ADDENDUM #1 John Ross Museum Anishinabe Design Project Number C39622

3-21-2023

This Addendum, issued March 21, 2023 shall take precedence over the original the Bid Package 01 Contract Documents and Specifications dated February, 28, 2023. Addenda modify the Bidding Documents in accordance with the Instructions to Bidders published in the Project Manual. Additional information may be provided by the Construction Manager at Risk.

1. <u>SHEET S201:</u>

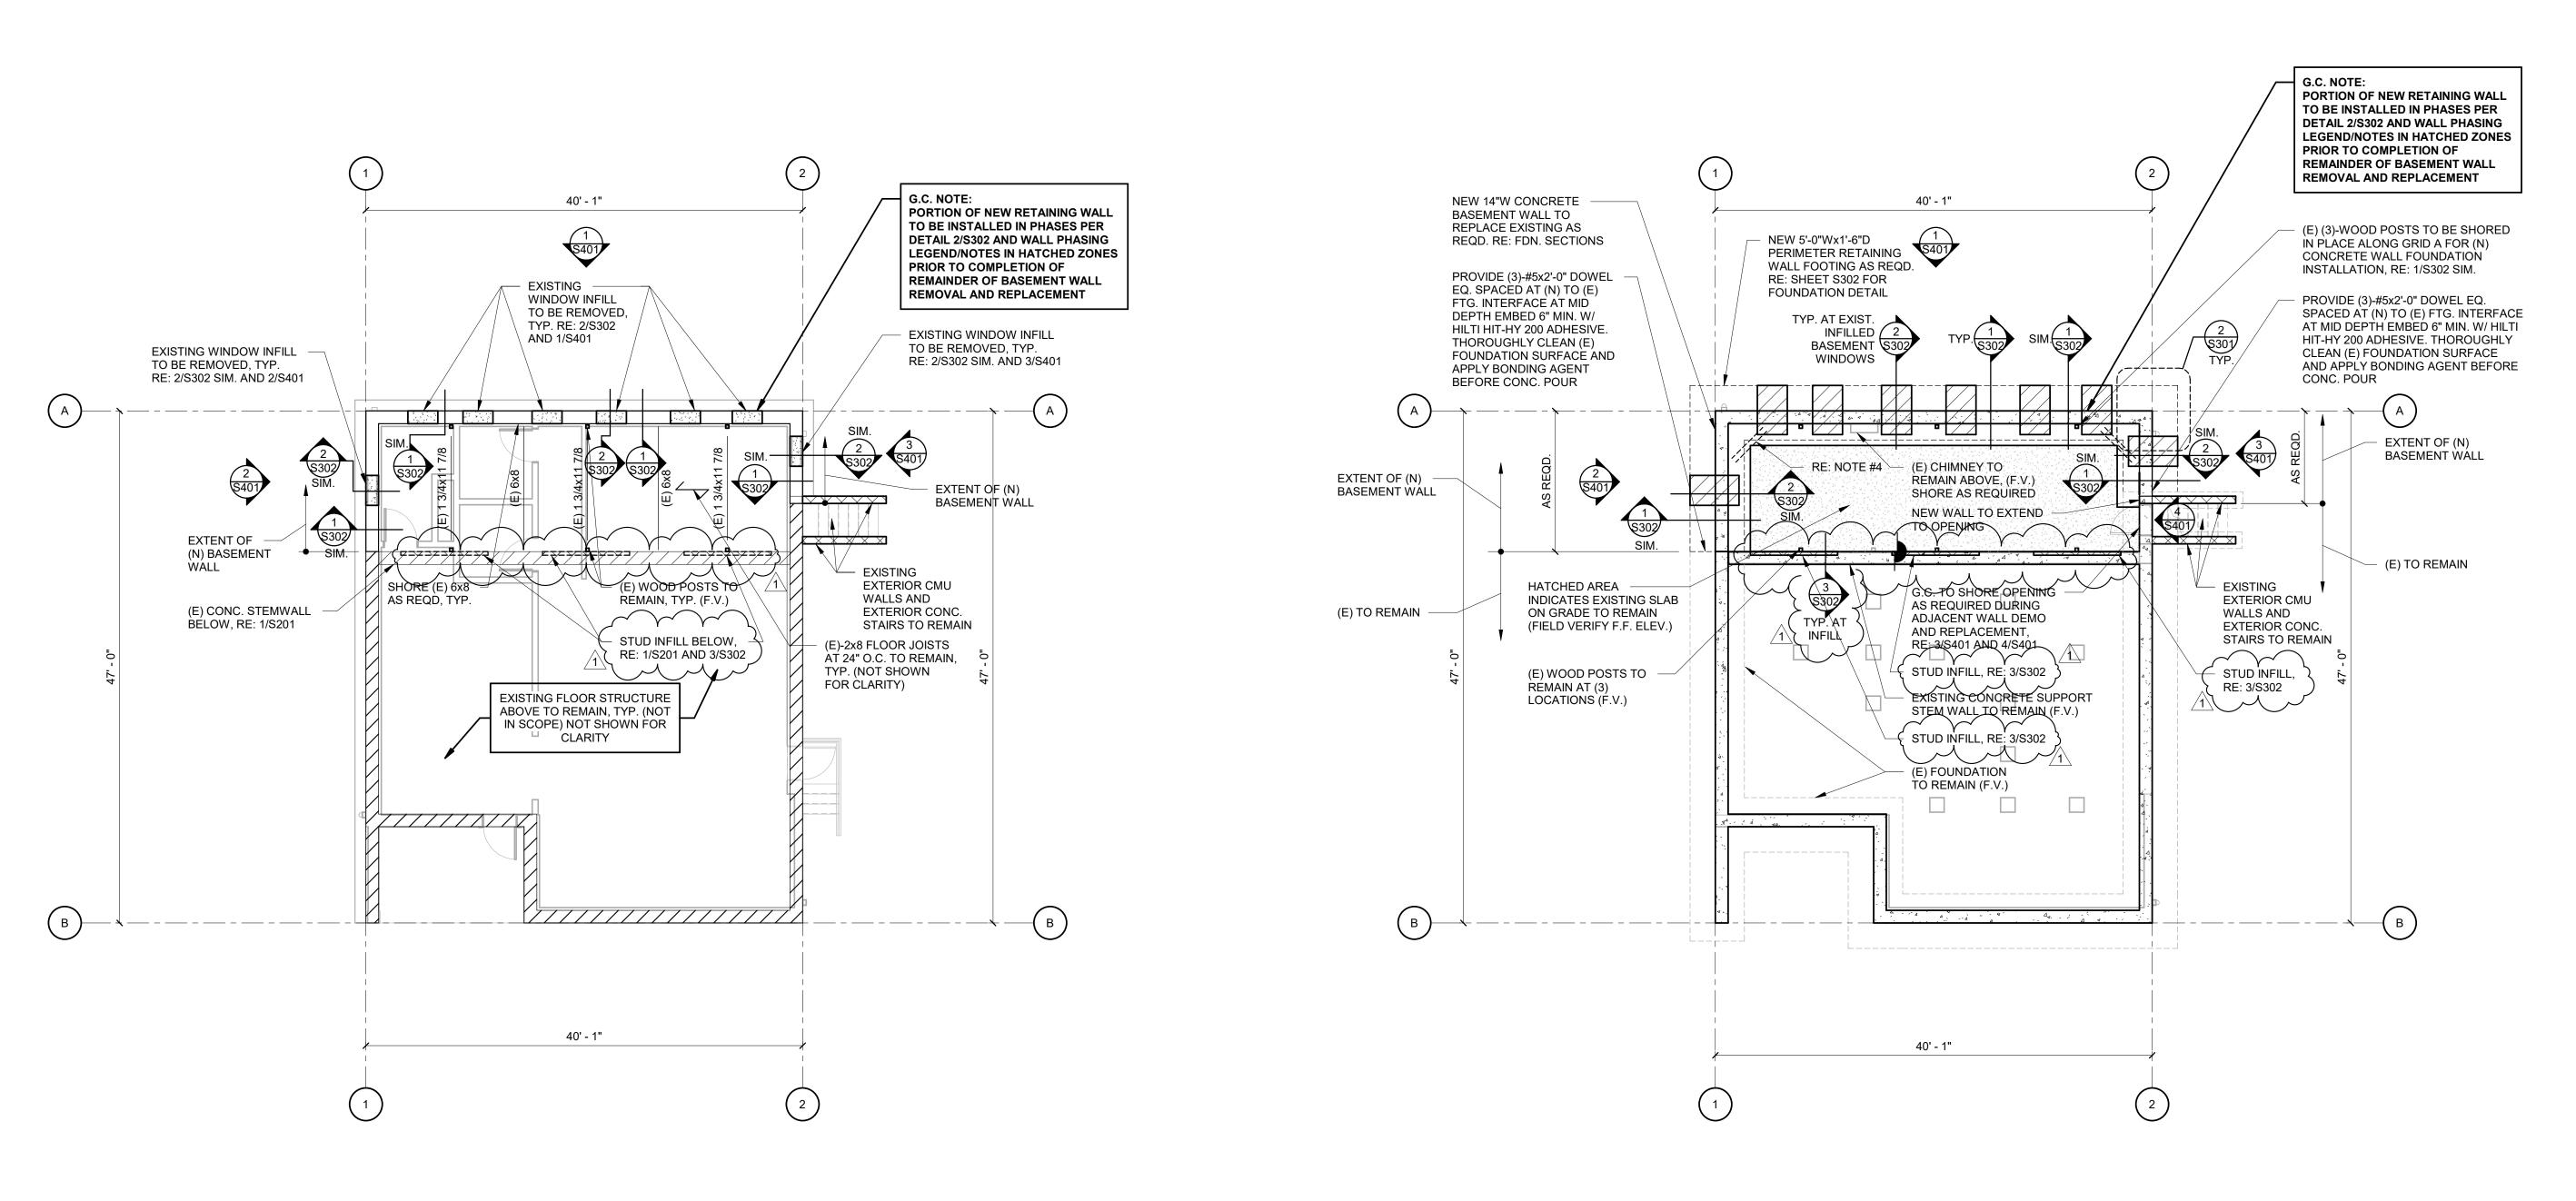
Replace Sheet. Indicates additional stud walls over retaining wall. Align infill studs directly below floor joists and, additional as needed. Fastener shall be non-corrosive.

2. <u>SHEET S302:</u>

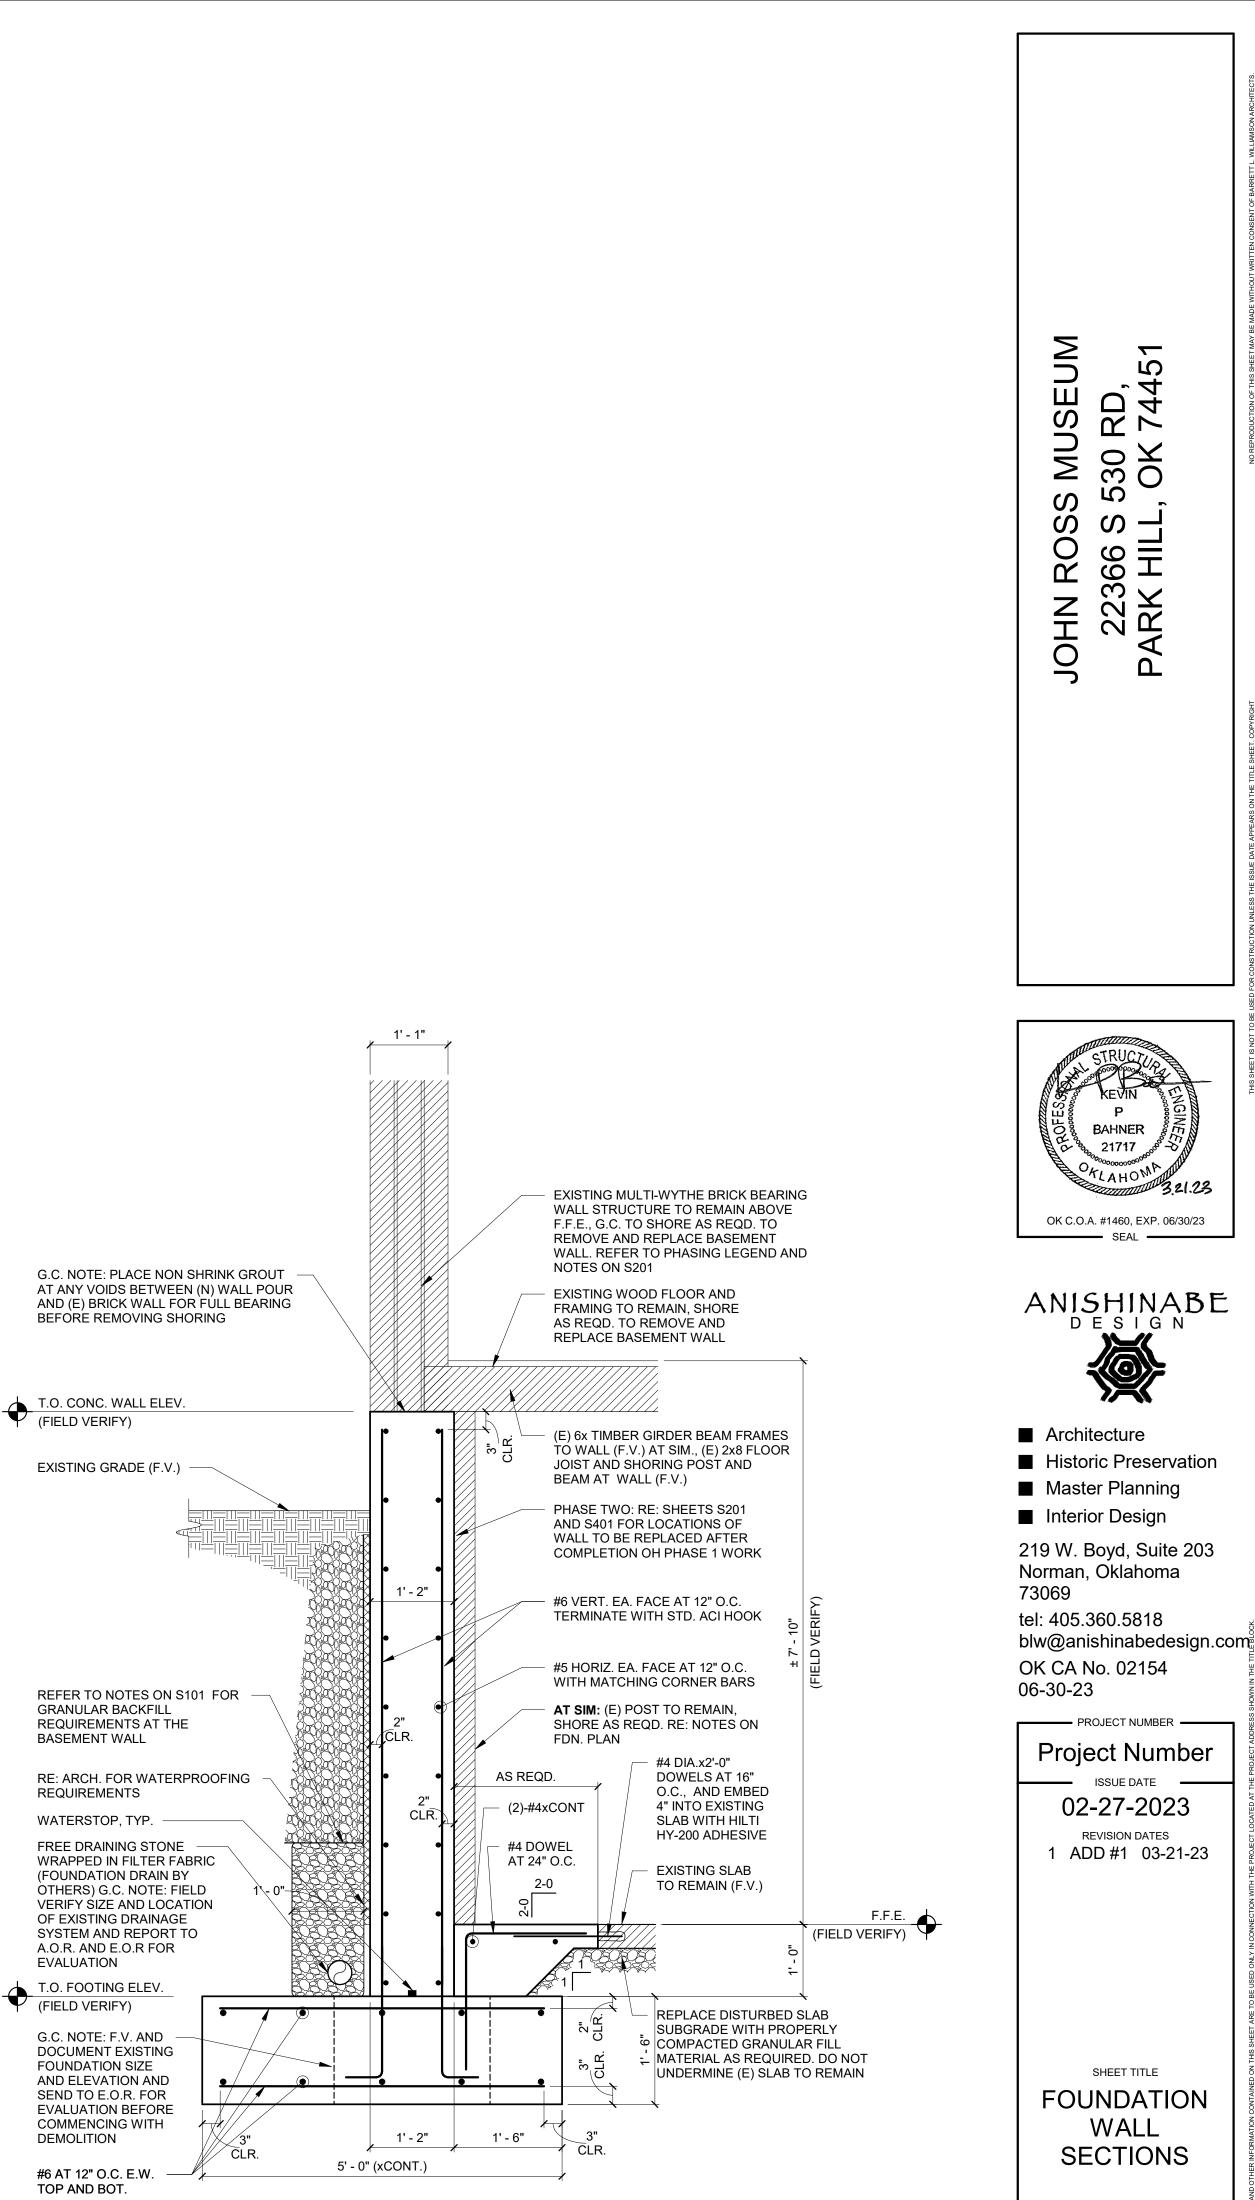
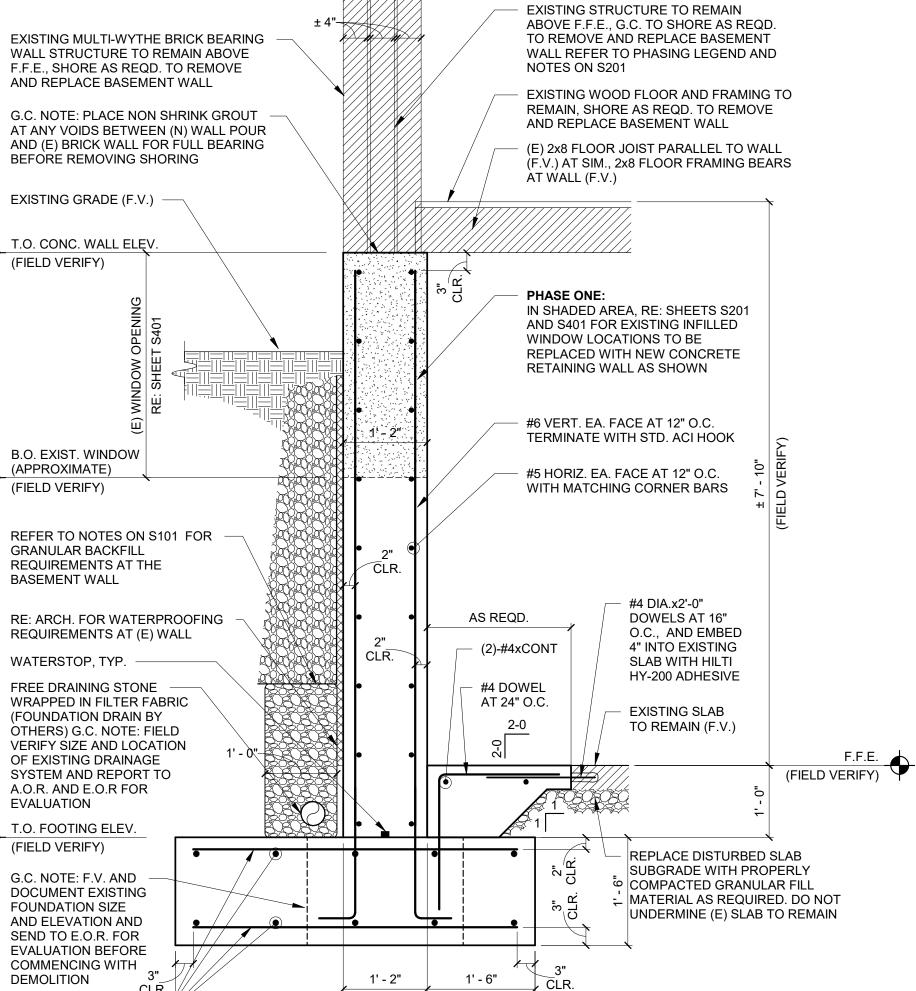
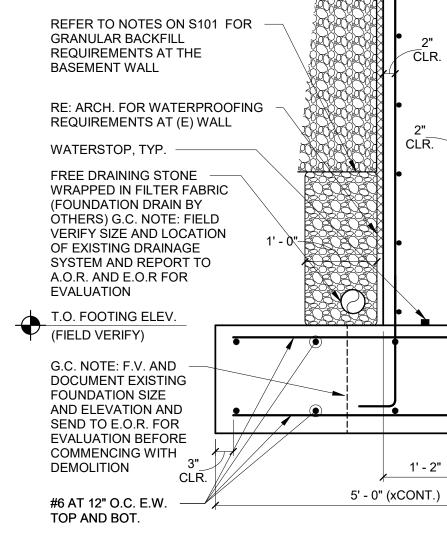
Replace Sheet. Indicates new detail. Align infill studs directly below floor joists and, additional as needed. Fastener shall be non-corrosive.
